Access Compliance Report

Public Rights-of-Way

Intersection ID: 2977	Main Street: ELDESLIE_DR	Cross Street: HARBURN_FOREST_DR	Location: NW
ADA ID: 173C8F548A93	Ramp Type: PerpDiag	Initial Pass/Fail: Fail	Overall Compliance: No
		Severity Score: 50

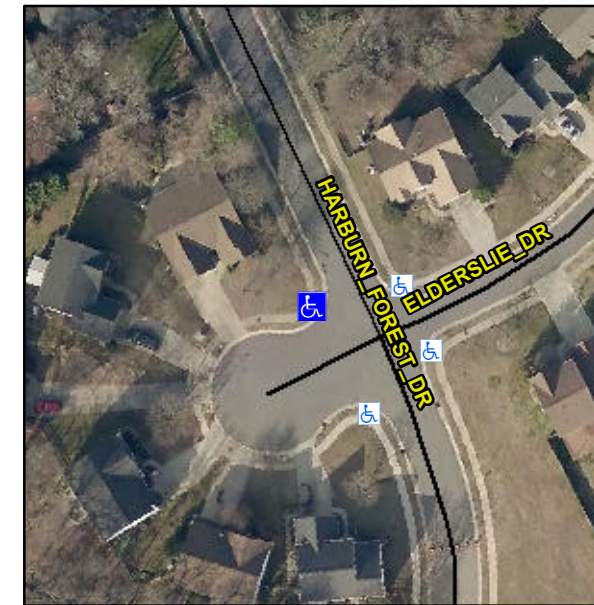
Not Found, R304.2.2, R304.5.3

Compliance	Description	Data	Compliance	Description	Data
N/A	Ramp Length (in)	48.0	No	Ramp Slope (%)	13.4
Yes	Ramp Width (in)	64.0	No	Ramp XSlope (%)	9.8
N/A	Flare Type LT	N/A	N/A	Flare Type RT	N/A
N/A	Flare Slope LT (%)	N/A	N/A	Flare Slope RT (%)	N/A
N/A	Flare Traversable LT?	N/A	N/A	Flare Traversable RT?	N/A
N/A	Landing Length (in)	N/A	N/A	DWS Provided?	N/A
N/A	Landing Width (in)	N/A	N/A	DWS Contrast?	N/A
N/A	Landing Slope (%)	N/A	N/A	DWS Length (in)	N/A
N/A	Landing X Slope (%)	N/A	N/A	DWS Full Width?	N/A
N/A	Landing Curb? (Y/N)	N/A	N/A	DWS Offset (in)	N/A
N/A	Shared Landing?	N/A			
N/A	Gutter Ponding?	N/A	N/A	Gutter Slope (%)	N/A
N/A	Gutter Lip Ht (in)	N/A	N/A	Gutter X Slope (%)	N/A
N/A	Painted X Walk1?	No	N/A	Painted X Walk2?	No
	X Walk 1 Direction	To S		X Walk 2 Direction	To E
N/A	X Walk 1 Width (in)	N/A	N/A	X Walk 2 Width (in)	N/A
	X Walk 1 Slope (%)	5.0		X Walk 2 Slope (%)	0.9
	X Walk 1 X Slope (%)	5.3		X Walk 2 X Slope (%)	5.3

Remove & Replace Curb Ramp With Two New Directional Ramps or Equivalent.
